**Subject:** Environmental Protection Agency (EPA) Safe Drinking Water Act Compliance  
Inspection Report.

**Follow-Up Site Visit Conducted by Virginia Department of Health-Office of  
Drinking Water's (VDH-ODW) Richmond Field Office**

The City of Richmond (COR) owns and operates a public waterworks (PWSID 4760100). The system is served by a Class 1 surface water treatment plant with a permitted capacity of 132 million gallons per day (MGD).

Figure 1. Distance of recycle discharge point and head of raw water pump stations (VDH)

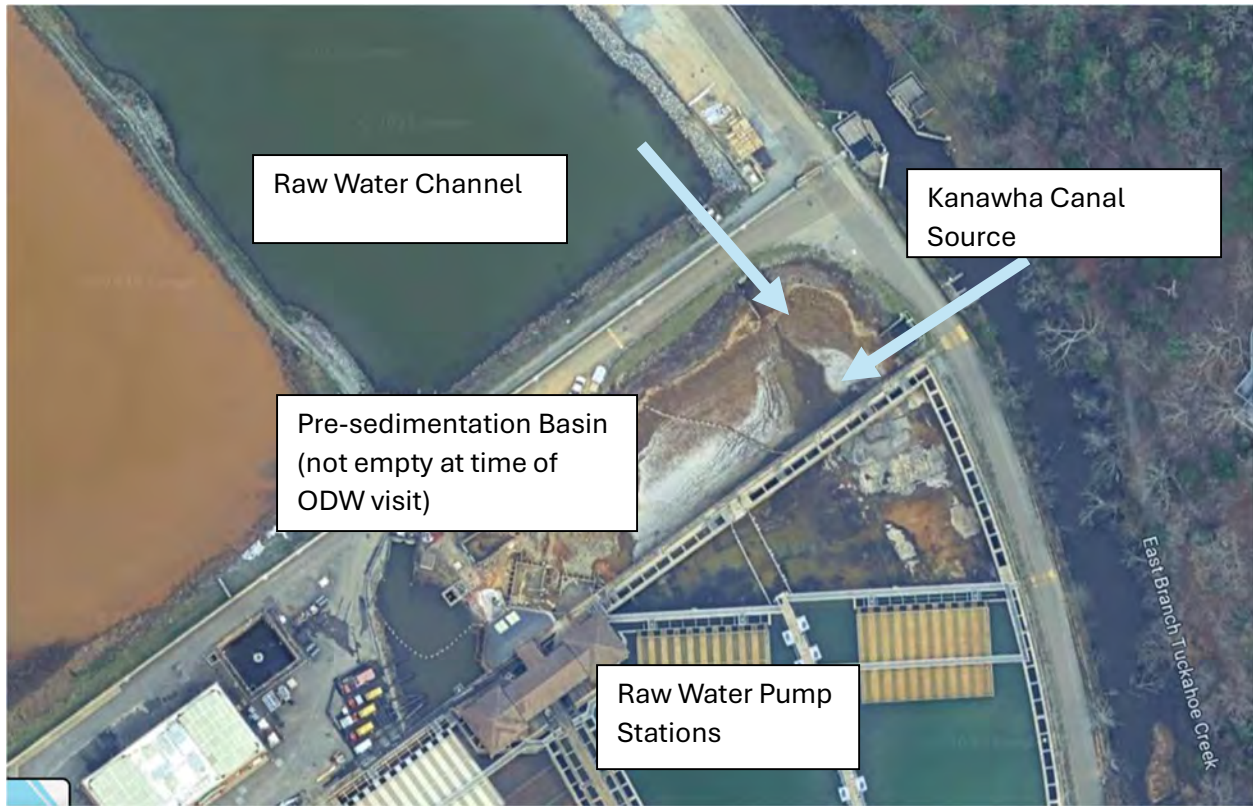
Obs. #	Category	Area of Concern	Supporting Observation	Relevant Citation	Richmond DPU Response 2025	VDH-ODW Observation 2025	Photograph (Appendix A)
<b>AOC-1</b>	Backwash Water Recycle Rule	There is a lack of flow control and monitoring of recycled water from lagoon to pre-sed. basin that could increase the risk of actual flow rates higher than flows metered in the upstream process.	Recycled water flows by gravity from the lagoon to the pre-sedimentation basin (raw water channel) through a manually operated sluice gate without flow measurement.	40 CFR §141.76(d)(2) requires the System to “list all recycle flows and the frequency with which they are returned.” 12VAC5-590-550.16.a.-f describes the recycle flow information that the waterworks is required to collect and retain on file. System risks exceeding turbidity standards described in 40 CFR §141.173(a)(1).	The City acknowledges this observation and confirms there is currently no flow monitoring infrastructure associated with the lagoon effluent. Flow is controlled from the lagoon with sluice gates. Backwash Wastewater flows are measured and reported on the Monthly Reports to the Virginia Department of Health (VDH). These flows represent the majority of recycled water. Attached is a copy of the July/August 2022 report, which defines the inspection period. The “recycled water” column in the report presents the majority of the flow into and subsequently out of the residual’s basin.	No change.  ODW did not observe any changes from 2022 observation, no flow measurement of recycled water, flows by gravity from the lagoon to the pre-sedimentation basin. The introduction of recycled water from the lagoon is approx. 4,500 feet upstream of the raw water pump stations to the plant. This is atypical of usual backwash recycle systems, which direct recycle water to the rapid mix or close vicinity to the start of the coagulation process and is closer to indirect potable water reuse than traditional backwash recycle.	Figure 1

Figure 5. Free ammonia readings (Left-EPA, Right- VDH)

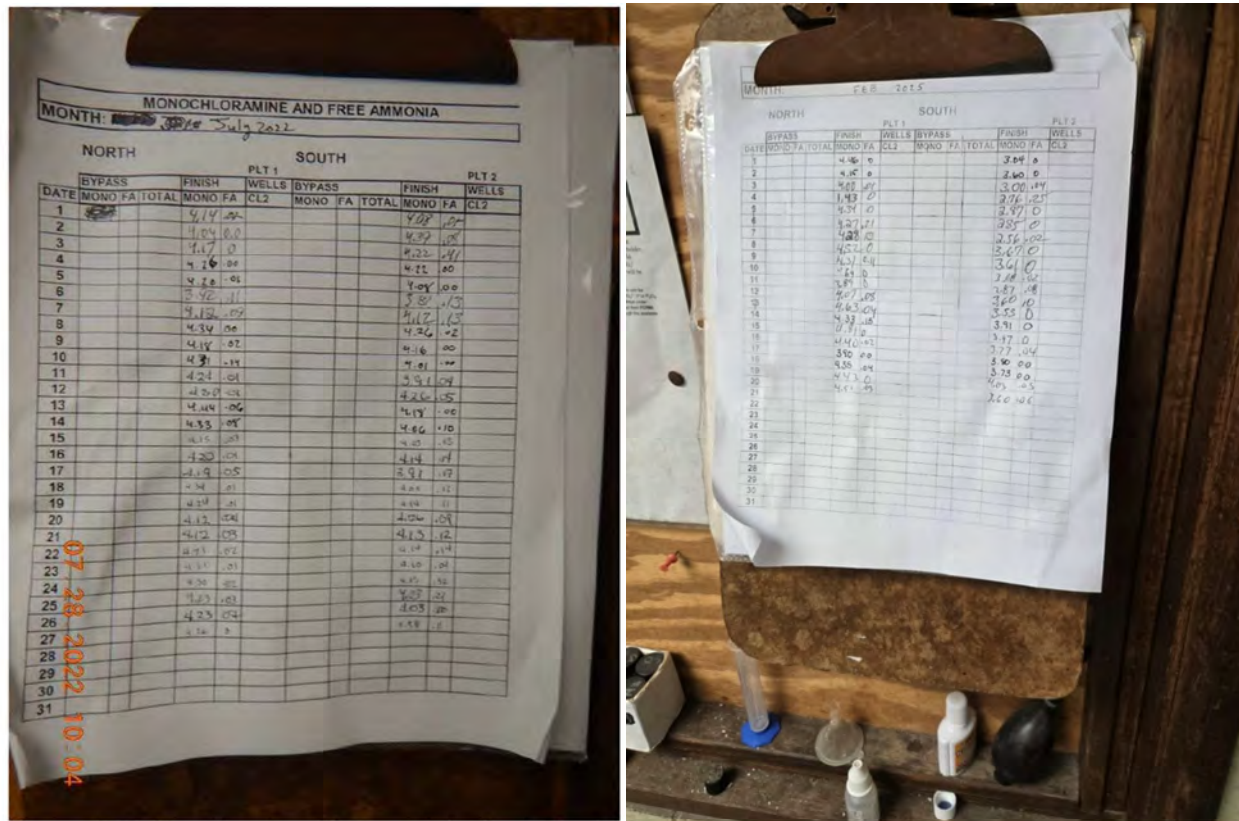
<b>AOC-7</b>	Finished Water Quality	Free ammonia concentrations exceed 0.1 mg/L when entering distribution.	July 2022 data sheets reflected several instances where free ammonia exceeds 0.1 mg/L, with a maximum of 0.41 mg/L.	12VAC5-590-1002 states, “Control should be sufficient to limit free ammonia leaving the chloramination facility to no more	The City acknowledges this observation and Operators are currently adjusting the dosage when free ammonia reaches 0.1 mg/L. Staff has been trained accordingly.	No change.  ODW reviewed February 2025 data sheets and observed 3 instances out of 40	Figure 5

Obs. #	Category	Area of Concern	Supporting Observation	Relevant Citation	Richmond DPU Response 2025	VDH-ODW Observation 2025	Photograph (Appendix A)
				than 0.1 mg/L as nitrogen.”		<p>readings that were above 0.1 mg/L.</p> <p>ODW recommends the investigation of plant controls and flow pacing of chemical feeds to optimize chemical dosing feedback loops to reduce the need to manually operate chemical feed pump rates. In addition, recommend consideration for online measurement of free ammonia and chloramine for chloramine process control.</p>	
<b>AOC-8</b>	Raw water coagulation channel	There was only one flash mixer for each plant and no operational procedure to respond to a failure.	There were not any redundant mixers for the flash mixer at each plant in the channel.	12VAC5-590-871.A.2 states, in part, “Where mechanical mixing devices are utilized, duplicate units or spare mixing equipment shall be provided.” System risks exceeding turbidity standards described in 40	Redundancy exists in the system today. Spare mixers are available, and the PM schedule is monthly. To address potential failures, additional measures of redundancy are being considered. In the meantime, a hot swap method is the first method of choice for redundancy.	<p>Addressed.</p> <p>Inline rapid mix in the raw water channel appeared operational. Four rapid mix units are still installed downstream of the inline mixer just upstream of the flocculators. Spare inline mixers observed.</p>	Figure 6

Figure 16. Plant 2 filters concrete (VDH)

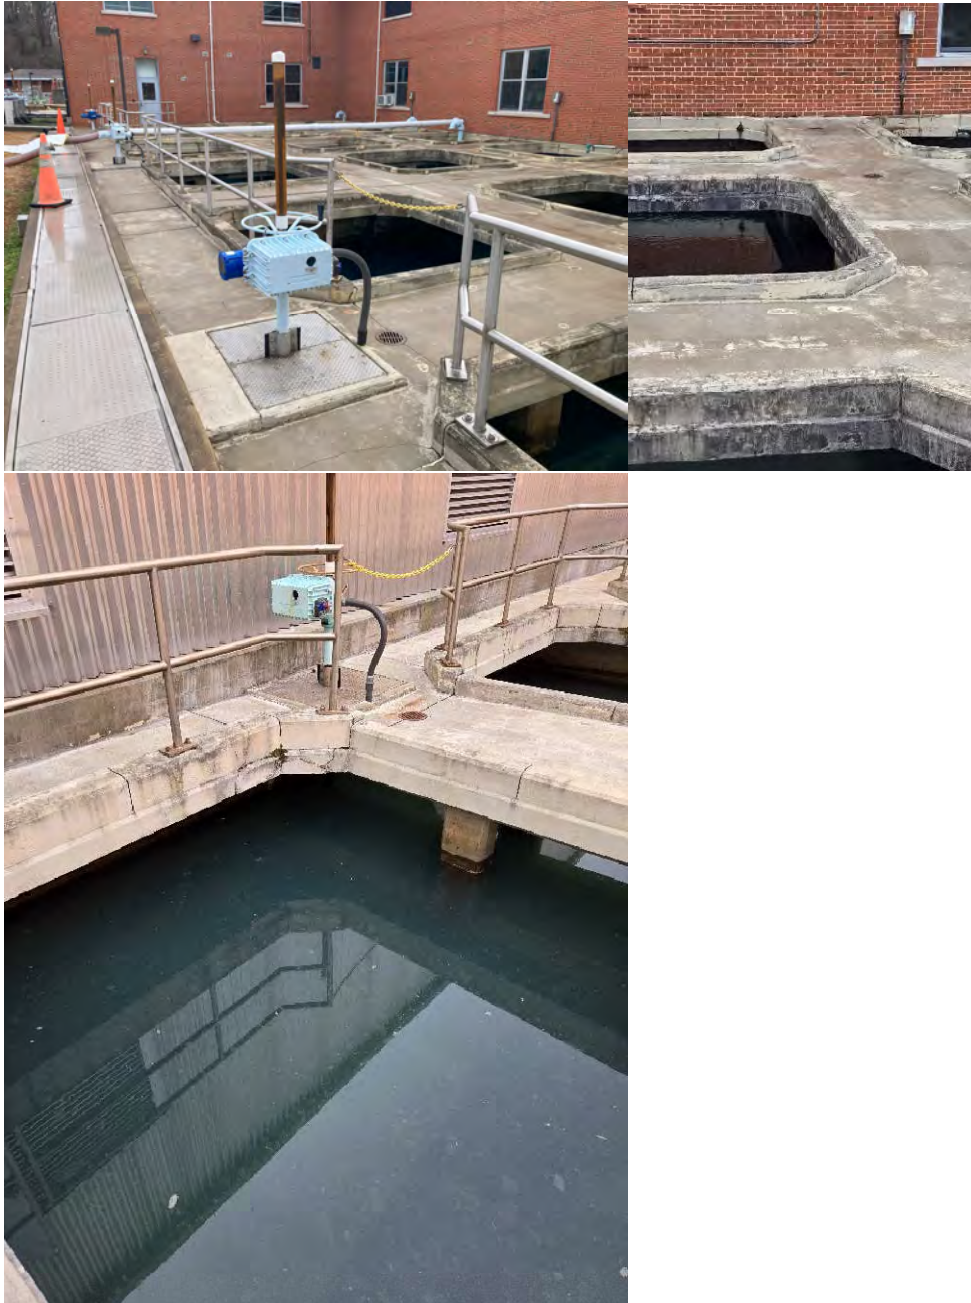
<b>AOC-17</b>	Plant 2 Filters	The exposed concrete filter beds and surface	Concrete structures	12VAC5-590-360.A states, “The owner shall provide and	Debris has been removed. The overall solution is being evaluated	Not substantially addressed.	Figure 14 Figure 15 Figure 16

Obs. #	Category	Area of Concern	Supporting Observation	Relevant Citation	Richmond DPU Response 2025	VDH-ODW Observation 2025	Photograph (Appendix A)
		structures appeared deteriorated due to weathering and age, and failure of additional filters could impact overall filter performance.	above filter beds had hairline cracks throughout. Structural debris was observed on the center wall inside of Filter 16.	maintain conditions throughout the entirety of the waterworks in a manner that will assure a high degree of capability and reliability to comply with Part II of this chapter. This requirement shall pertain to the source water, transmission, treatment, storage, and distribution system facilities and the operation thereof. The owner shall identify and evaluate factors with the potential for impairing the quality of the water delivered to the consumers. Preventative control measures identified in Part II of this chapter shall be promptly implemented to protect public health." System	through a larger CIP project.	ODW observed some surface level skim coating of previous hairline cracks on the walkways around the Plant 2 filters. Some structural issues and cracking still observed beneath the walkways. Concrete structure cracking and separation also observed on walkway between raw water pumps and head of sedimentation basins. Conversations with consulting engineer indicate that some money anticipated to be used to address concrete concerns may be diverted to move critical electrical equipment away from flood prone areas in response to the January 6, 2025, event.	Figure 17 Figure 18

Figure 22. Filtered water pumps upgrades (COR)

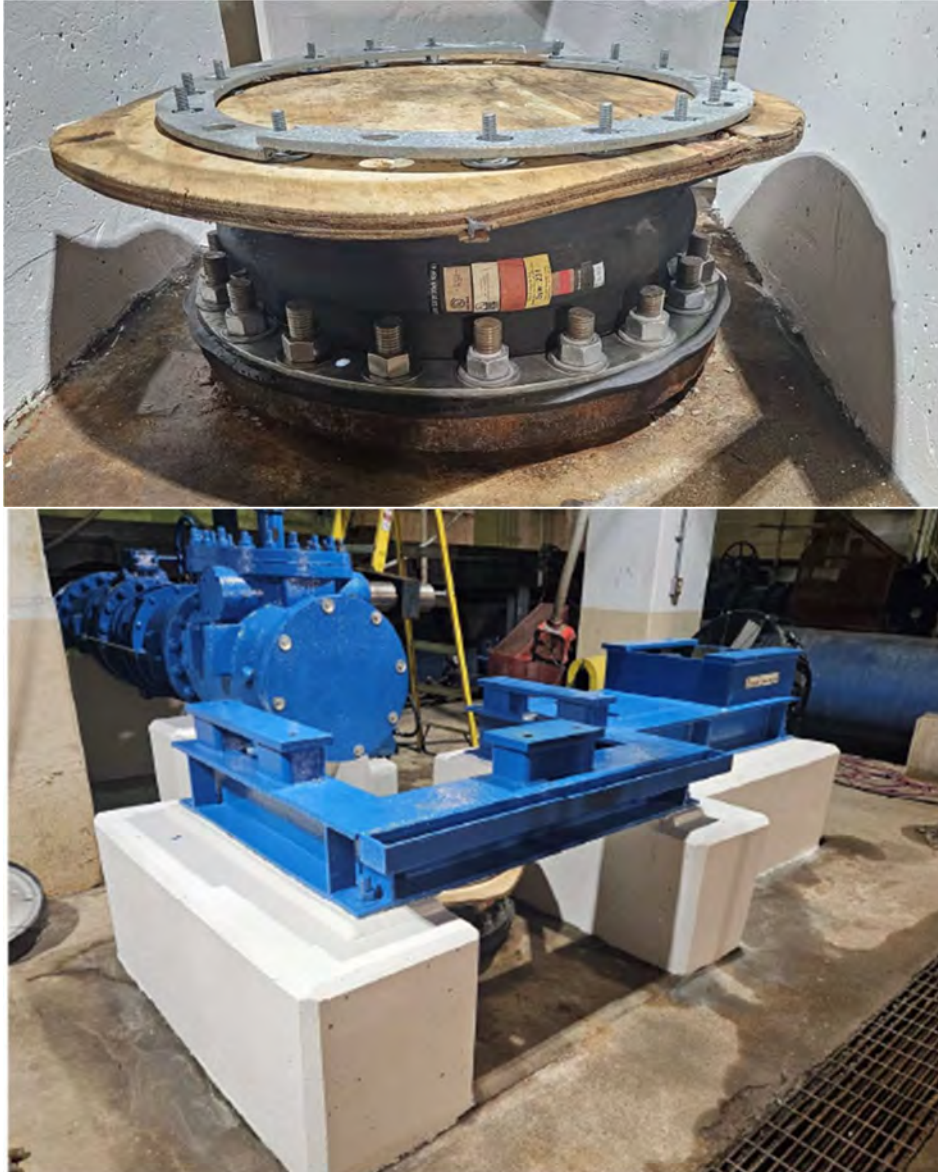
Obs. #	Category	Area of Concern	Supporting Observation	Relevant Citation	Richmond DPU Response 2025	VDH-ODW Observation 2025	Photograph (Appendix A)
						and MOR data completion software to ensure they are able to report above 2.0 NTU turbidities.	
<b>AOC-22</b>	Clearwell Pumps	Pumps are corroded and deteriorated at the base, risking a loss of capacity due to deteriorated structures	EPA observed significant corrosion at the base of Pumps 1, 2, and 3 that move water from the clearwell to the finished water basin.	12VAC5-590-360.A states, "The owner shall provide and maintain conditions throughout the entirety of the waterworks in a manner that will assure a high degree of capability and reliability to comply with Part II of this chapter. This requirement shall pertain to the source water, transmission, treatment, storage, and distribution system facilities and the operation thereof. The owner shall identify and evaluate factors with the potential for impairing the quality of the water	The City acknowledges this observation and is addressing this through an O&M project. Pump N-2 refurbishment is nearing completion (see pics 115 and 116). Pumps N-1 and N-3 refurbishment will follow accordingly.	Partially addressed. Corrosion still observed at time of site visit on several pumps in the pipe gallery area. Some pumps appear to have relatively new bolts attached to still corroded bracketing and/or base pedestals. New bolts appear to be uncoated, may accelerate rusting.	Figure 21 Figure 22 Figure 23

Figure 29. Byrd Park Reservoir roof replacement plans showing overflow

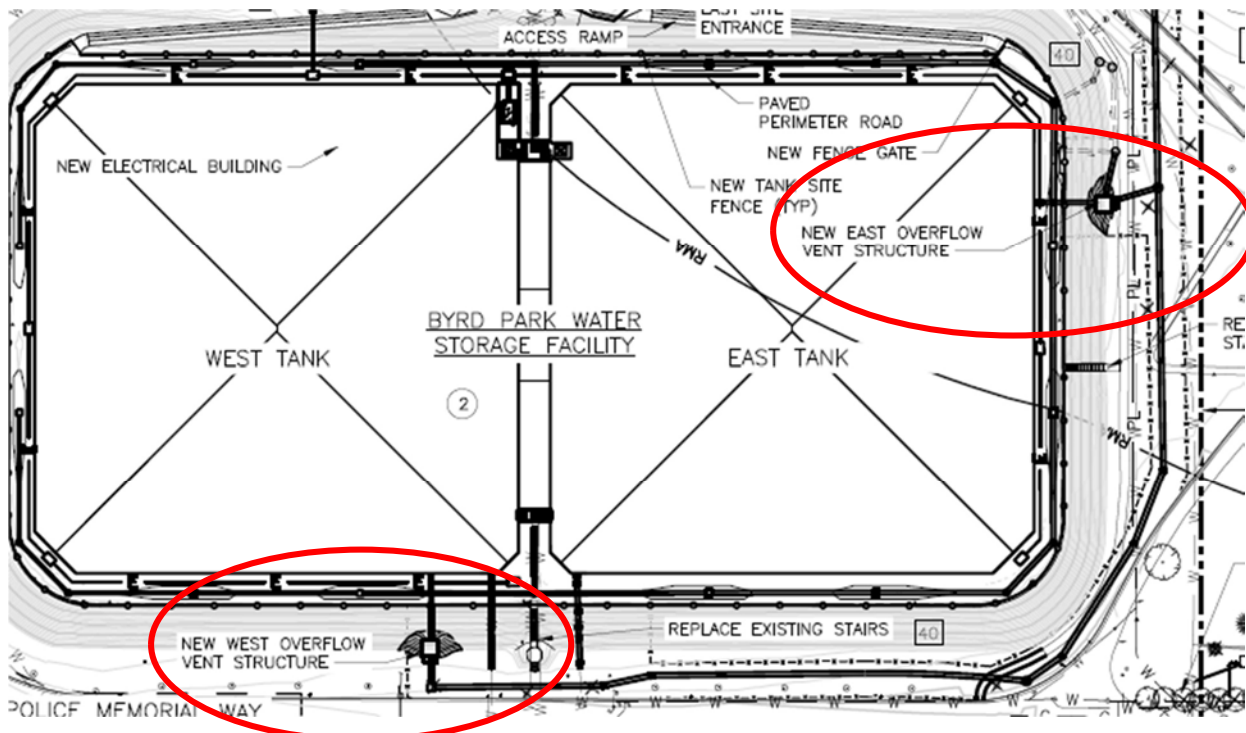
Obs. #	Category	Area of Concern	Supporting Observation	Relevant Citation	Richmond DPU Response 2025	VDH-ODW Observation 2025	Photograph (Appendix A)
<b>AOC-24</b>	Byrd Park Reservoir	There was a risk of contamination from rooftop stormwater due to valve pit flooding, and there is a lack of inspections of the pit.	The valve pit between the two cells of the reservoir was flooded. The valve pit shares common walls with the reservoir cells, and the walls are penetrated by multiple pipes. System Representatives were not informed of the flooding and did not know the cause, indicating the valve pit is not inspected on a regular basis.	12VAC5-590-1081.H states, "The roof and sidewalls of all structures shall be watertight with no openings..."	The deficiencies observed during the inspection were corrected shortly following the inspection. Long term solutions will be altered due to the CIP project that is currently underway and scheduled for completion in 2028.	Follow-up needed  Byrd Park Reservoir is in active construction of roof replacement. One cell of the reservoir is offline.	Figure 27 Figure 28

Figure 51. Pre-sed basin screens (Top-EPA, Lower Left- COR, Lower Middle and Right-VDH)

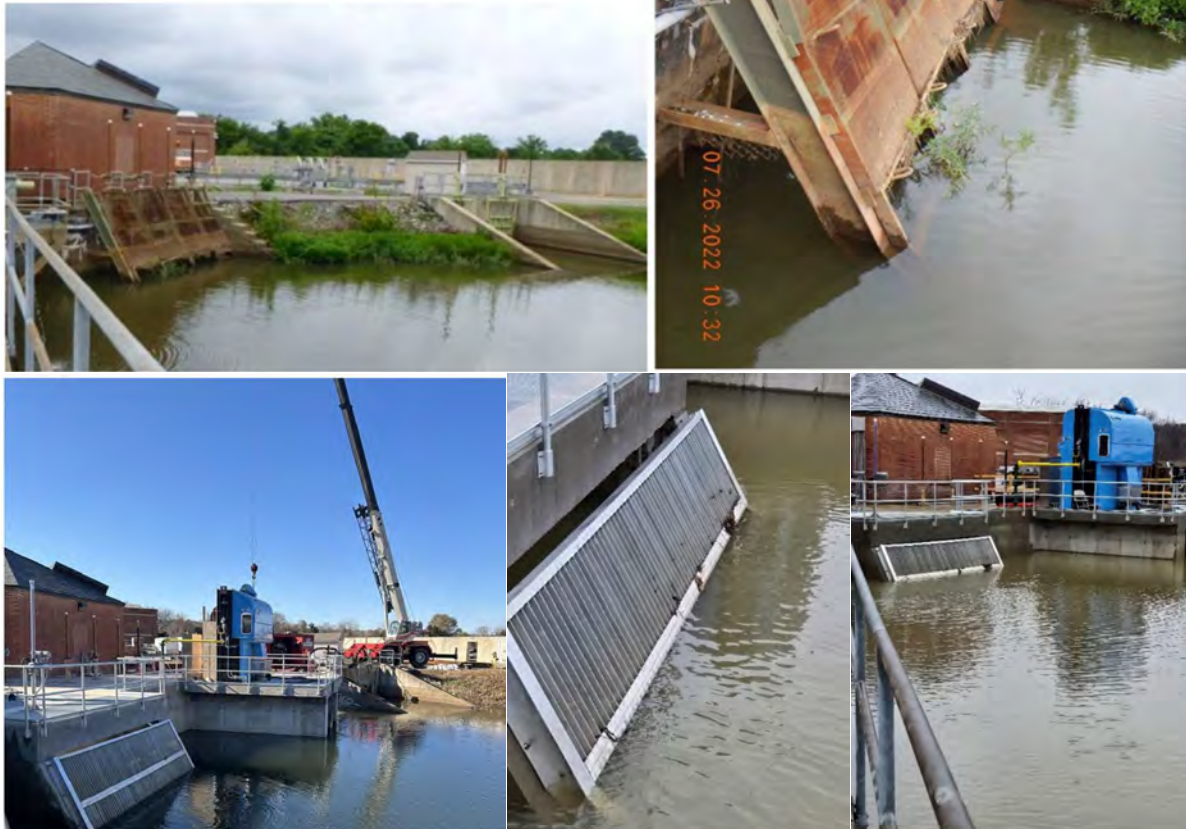
<b>O-4</b>	EPA observed two bar screens at the southern end of the sedimentation basin with vegetation growing around the structure. The Superintendent stated the screens are cleaned once/week	Addressed.  Significant vegetation not observed around screen.	Figure 49
<b>O-5</b>	EPA observed at least ten approximately 300-gallon containers of polymer without secondary containment near the dewatering operation to the northeast of the pre-sedimentation basin. The Superintendent explained the polymer is used in the dewatering process for the lagoon dredge material.	No change.  Three to four chemical totes observed in same area noted. No secondary containment observed.	Figure 50
<b>O-6</b>	EPA observed raw water screens at the treatment plant intake that were in poor condition with corrosion and holes; one of the screens was not attached and had fallen to the bottom of the raw water basin. These screens were permanently out of service per comments by System Representatives.	In progress.  Raw water screens appeared to be replaced on one side of the intake basin. The other side is under construction. Traveling screens were also installed at the intake screen discussed by EPA.	Figure 51

Figure 57. 2020 Filter media evaluation (VDH)

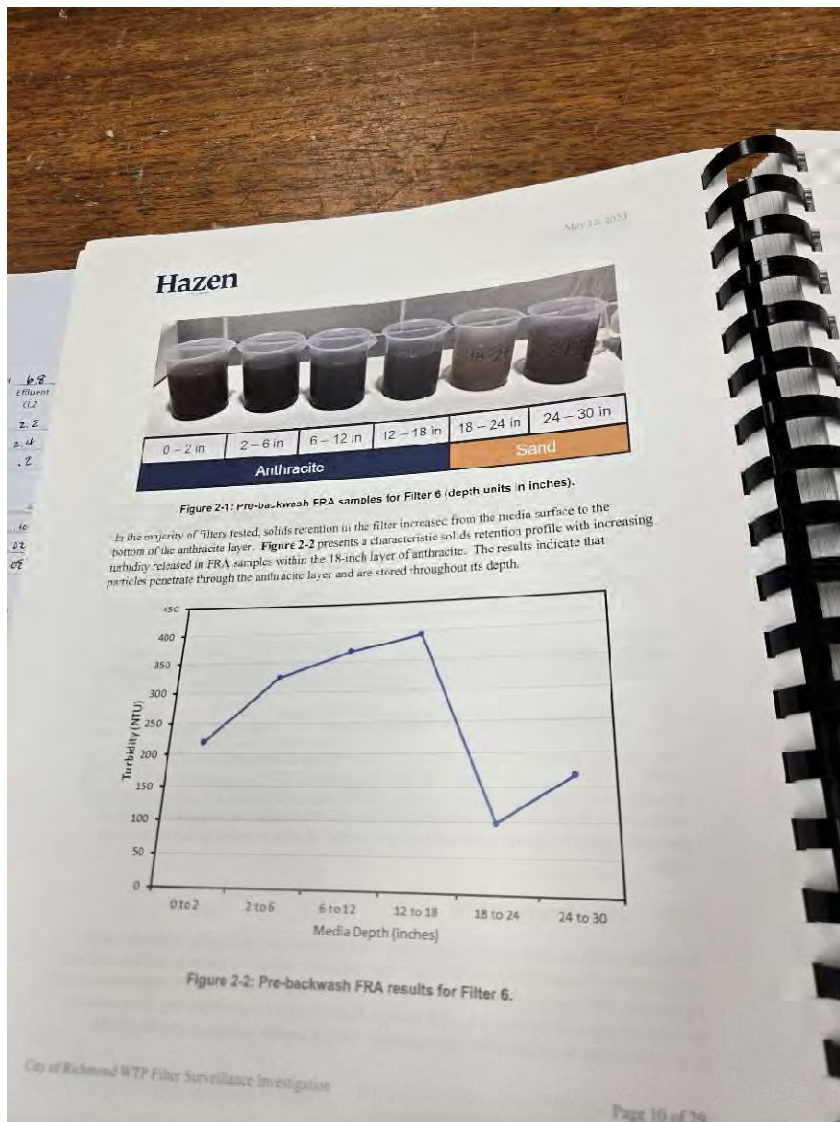
<b>O-11</b>	Filters 14, 15 and 19 of Plant 2, as well as Filter 2 of Plant 1 were out of service at the time of inspection due to issues with rate of flow effluent valve actuators. No date was provided for their return to service.	Filters 2, 14, 15, and 19 were addressed.  Filters 7, 9, 11, and 21 were out of service at time of inspection. Filter effluent valve replacement projects as well as other filter related projects were ongoing during inspection.	Figure 56
<b>O-12</b>	The Superintendent stated that a media assessment was recently conducted with the filters, and a media changeout is in early design stages. The Superintendent noted that the filter media was not found to be in good condition and some filters were missing several inches of media; however, none of the filters were in such poor condition that they needed to be removed from service. The Superintendent explained that assessment of the concrete and structural components of the filters would be conducted separately.	In progress.  Filter media replacement included in filter upgrade project that also includes upgrade of filter effluent valves. Project is in progress, started in late February 2025.	Figure 57

Figure 75. PLC in electrical room Columbus Pump Station, discharge setpoint at 0.00 psi (Left-EPA, Right-VDH)

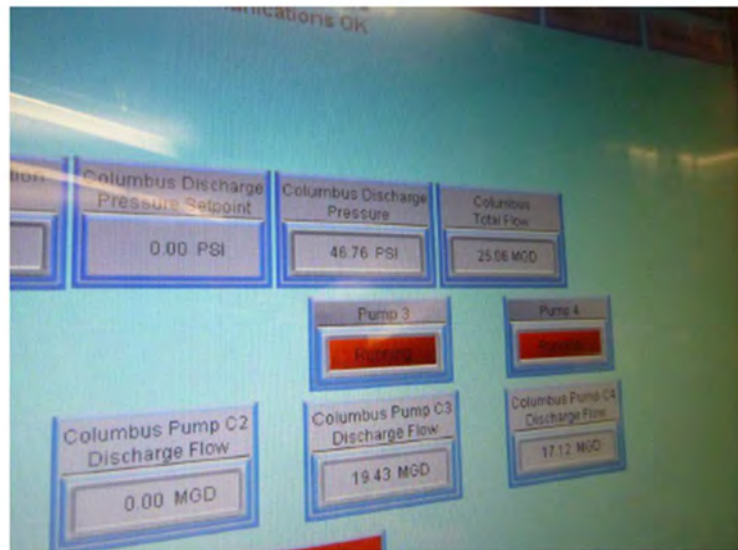
<b>O-30</b>	EPA observed temporary fencing around the front of the tank and permanent security fencing without barbed wire at the rear of the tank at Huguenot Road. System Representatives explained there is ongoing construction in the area and the temporary fencing will be replaced. EPA also observed staining on portions of the tank	<p>No change.</p> <p>No security fencing observed, temporary fencing removed, and no permanent fencing put in place. Tank staining observed at time of inspection. 2023 tank inspection recommends exterior power wash, and immediate repairs to roof support beams.</p>	Figure 73
<b>O-31</b>	EPA observed that the programmable logic controller (PLC) display screen in the main pump station building was not operational at Columbus Pump Station	<p>Addressed.</p> <p>PLC display screen functional at time of inspection.</p>	Figure 74
<b>O-32</b>	EPA observed the PLC screen in the electrical building was functioning and showed that the Columbus Discharge Pressure Setpoint was "0.00 PSI". The Program & Operations Supervisor was unsure why the set point was 0.00	<p>No change.</p> <p>Setpoint is still at 0.00 psi, however discharge pressure showing as 40.39 psi. Standard operating procedures not available to describe pressure setpoint reasoning.</p>	Figure 75
